Improved Technical Specifications

Quad Cities Station

Volume 8:
Section 3.7

3.7 PLANT SYSTEMS

FIGURE 4.8.F-1
SAMPLING PLAN FOR SNUBBER FUNCTIONAL TESTING

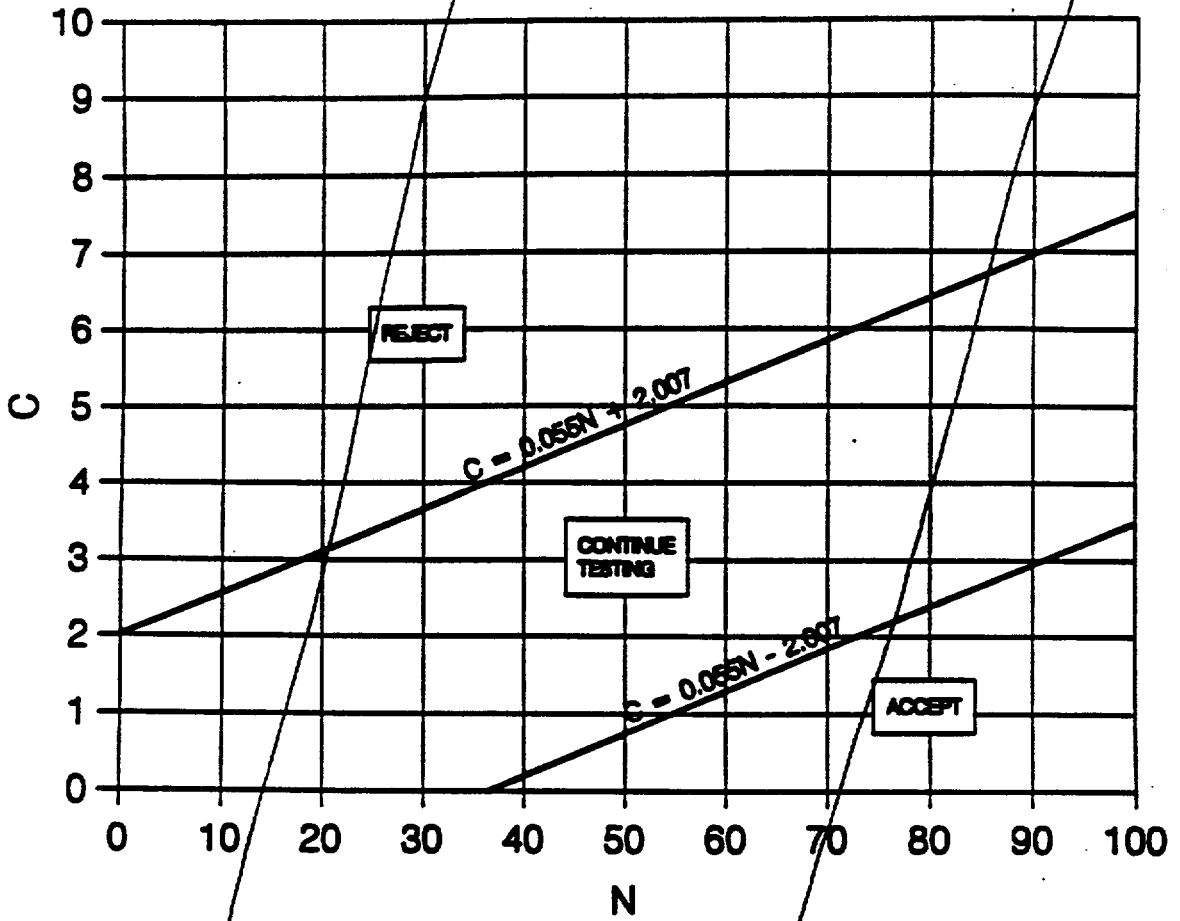
- a. At least 10% of the total of each type of snubber shall be functionally tested either in-place or in a bench test. For each snubber of a type that does not meet the functional test acceptance criteria of Specification 4.8.F.6, an additional 10% of that type of snubber shall be functionally tested until no more failures are found or until all snubbers of that type have been functionally tested; or
- b. A representative sample of each type of snubber shall be functionally tested, in accordance with Figure 4.8.F-1. "C" is the total number of snubbers of a type found not meeting the acceptance requirements of Specification 4.8.F.6. The cumulative number of snubbers of a type tested is denoted by "N". At the end of each day's testing, the new values of "N" and "C" (previous day's total plus current day's increments) shall be plotted on Figure 4.8.F-1.
